PROJECT: AP600

SUBJECT: SUMMARY OF MEETING TO DISCUSS AP600 REACTOR SYSTEM DESIGN

WESTINGHOUSE/NRC AP600
MEETING ATTENDEES
APRIL 25 AND 26, 1995

ELIMINATE ONE PRHR HX

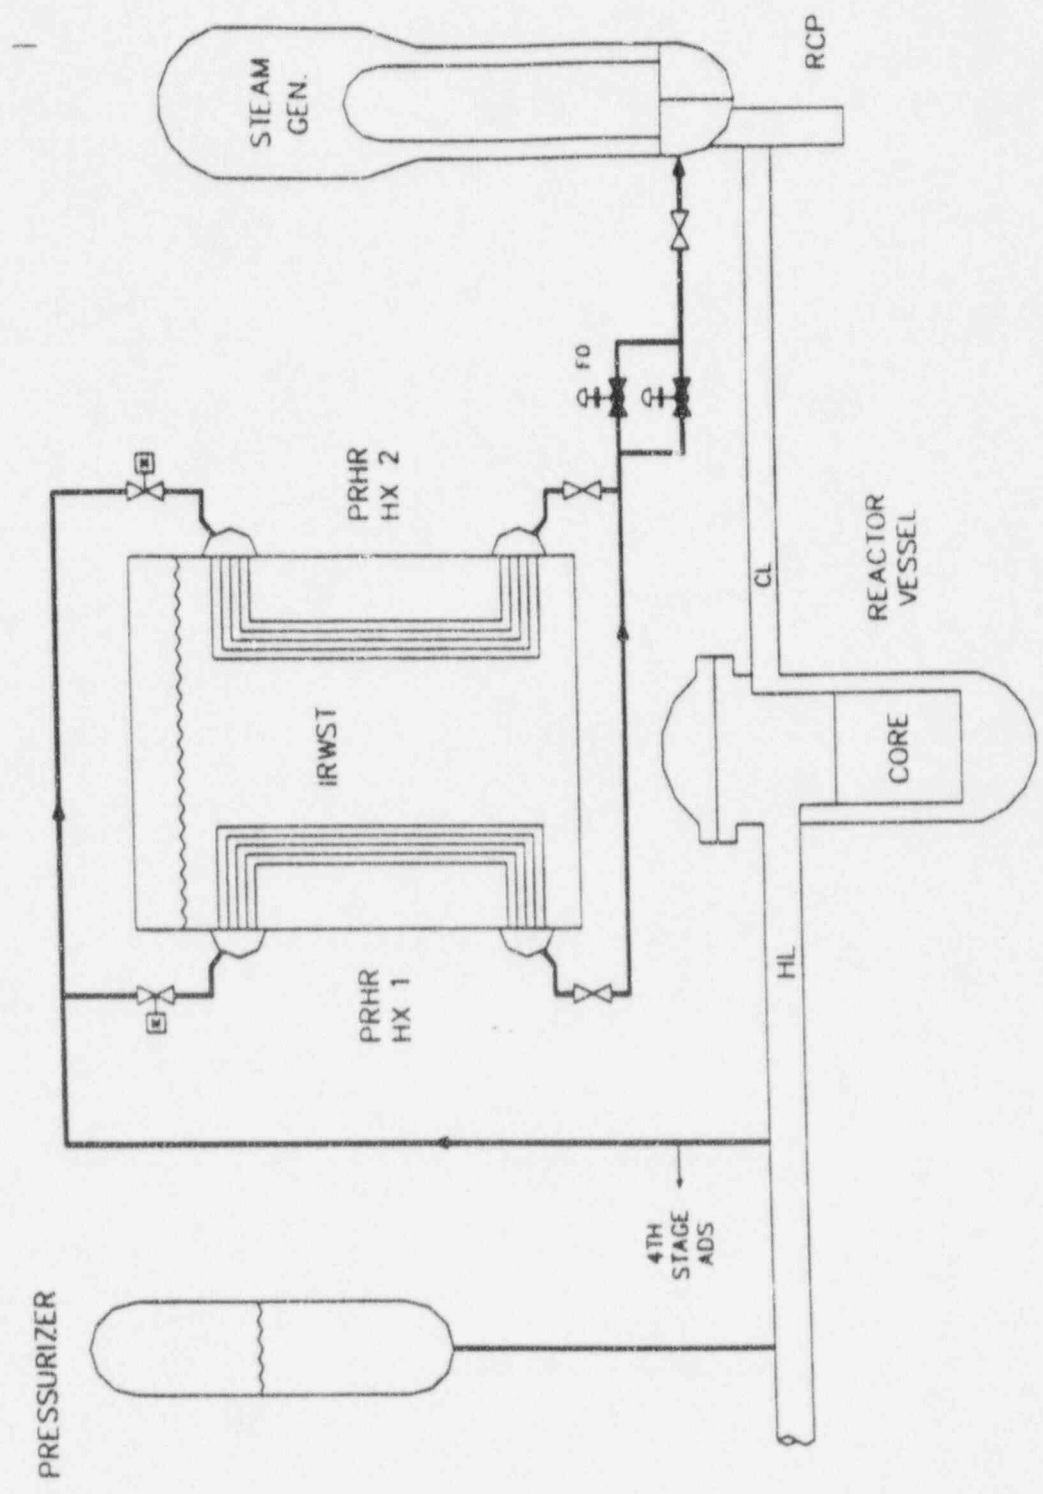
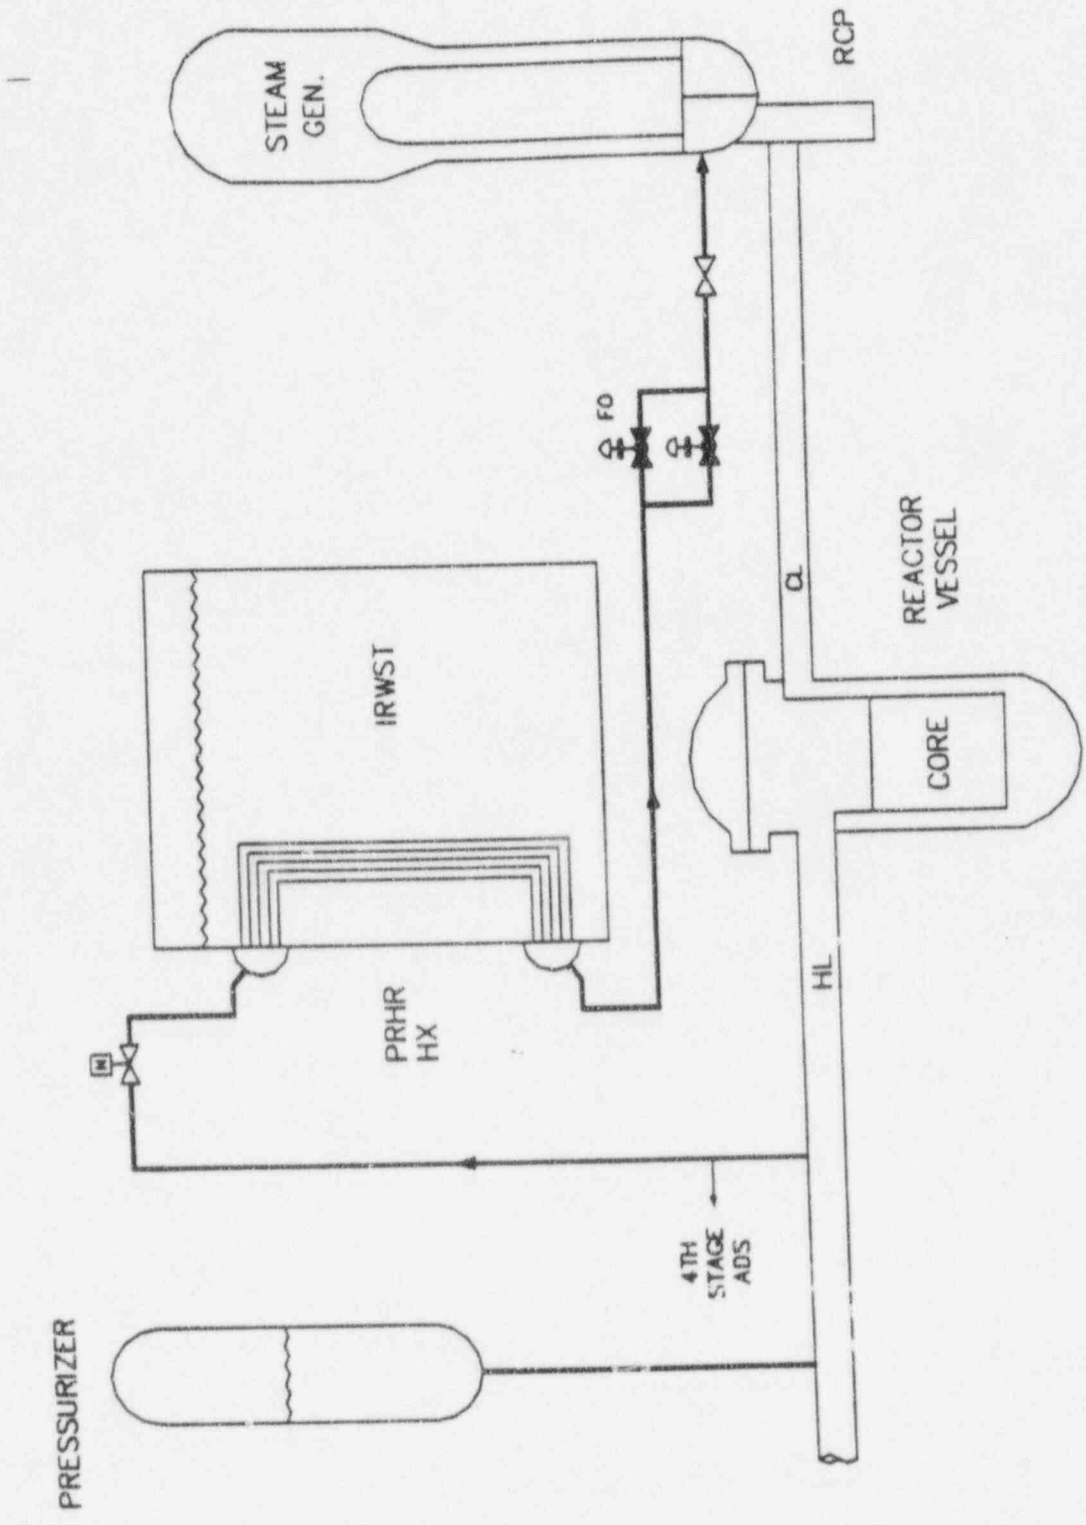
- **Change**
 - Eliminate one PRHR HX
 - Eliminate associated inlet / outlet valves
 - Add Tech Spec to allow limited leakage (ala SG)

- **Basis**
 - No affect on limiting heatup accidents
 - AP600 Tech Spec only require one HX
 - Reduces chance of accidents (PRHR HX tube rupture)
 - Reduces excessive RCS cooldown / thermal stratification

USE SQUIB VALVES IN IRWST

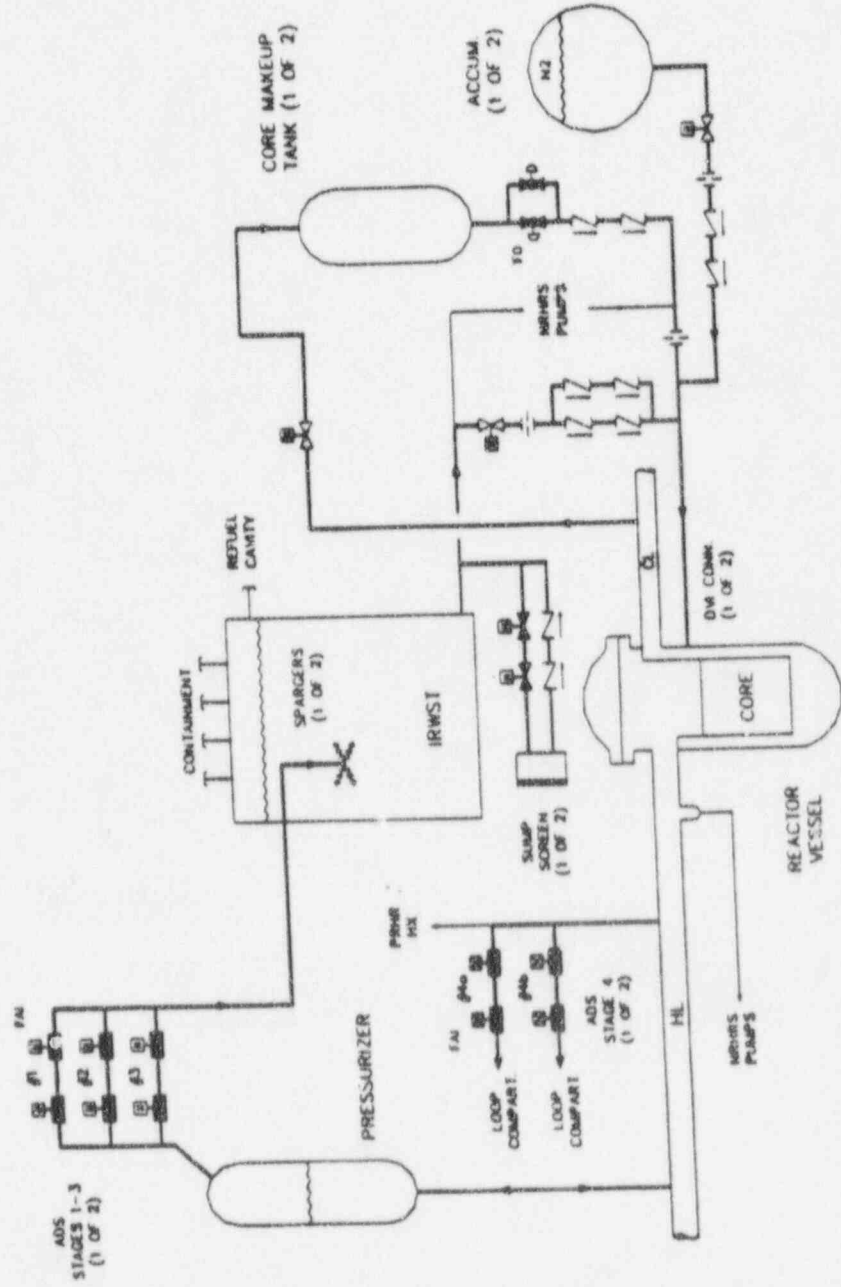
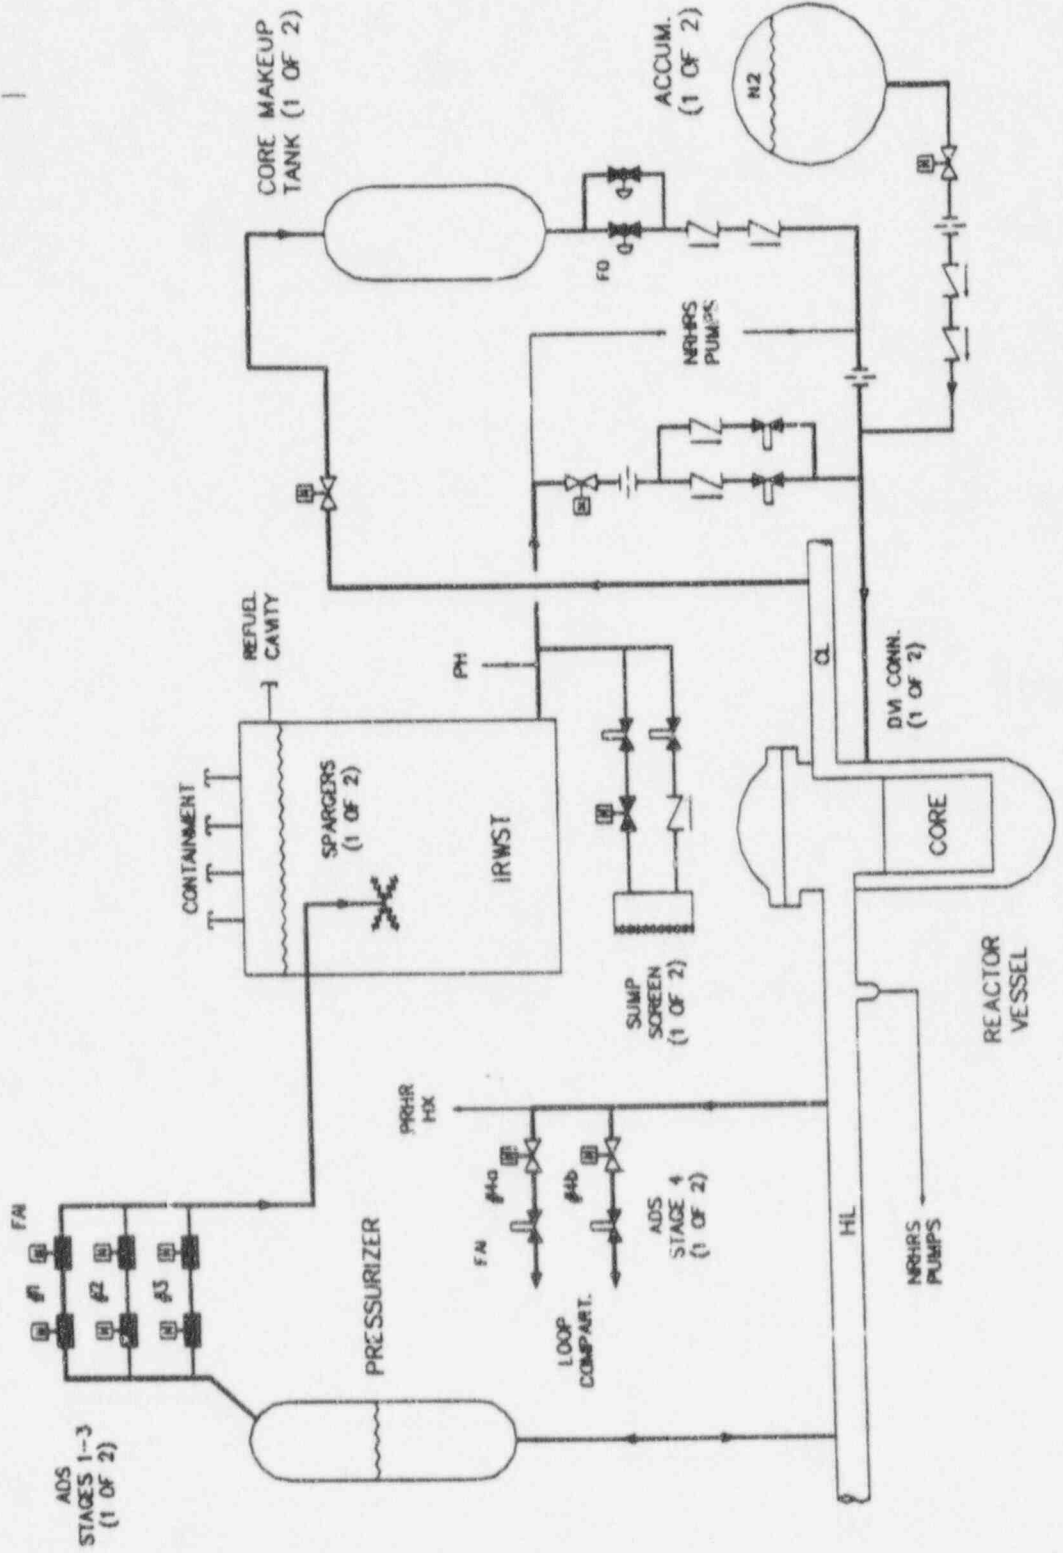
- Replace 4 check valves in IRWST injection lines
 - Actuate on ADS stage 4 signal
- Replace 2 check valves & 2 MOVs in containment recirc lines
 - Actuate on low IRWST level (same as current MOVs)

- Reduce chance of leakage during normal operation
- Reduce uncertainty in IRWST check valve opening
 - IRWST check valves now only see low DP

ADS STAGE 4 EXAMPLES

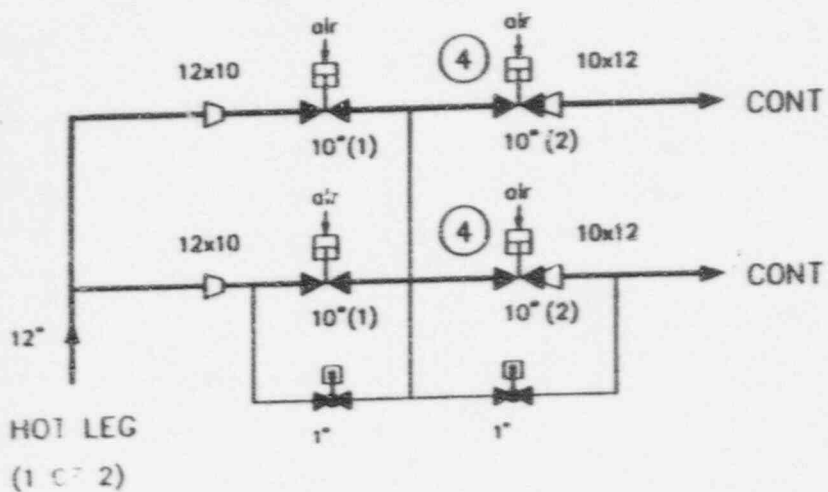
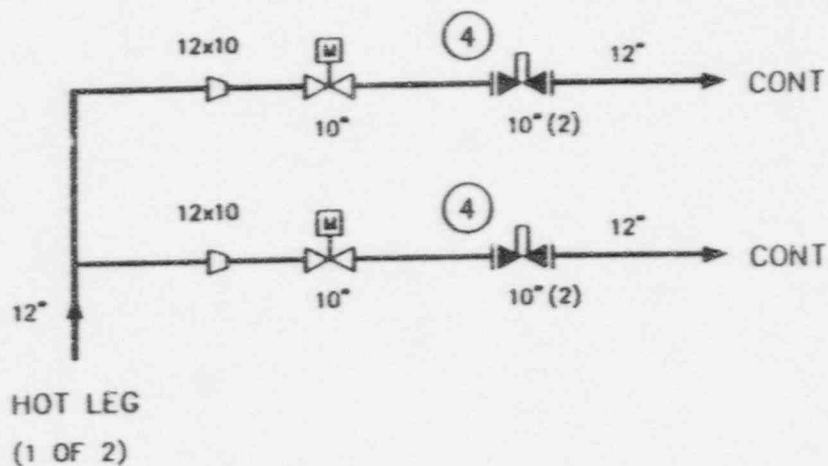
- **Change**
 - One of approaches identified in 2/15/94 change report

- **Impact**
 - Testing; none, already incorporated in tests
 - Analysis; none, evaluated in 2/15/94 change package
 - PRA; none, already incorporated in PRA rev 2

- NOTE: (1) Upstream isolation valve sequenced open before opening down stream control valve.
 (2) Stage 4 ADS valves blocked from opening when RCS > 1200 psig.
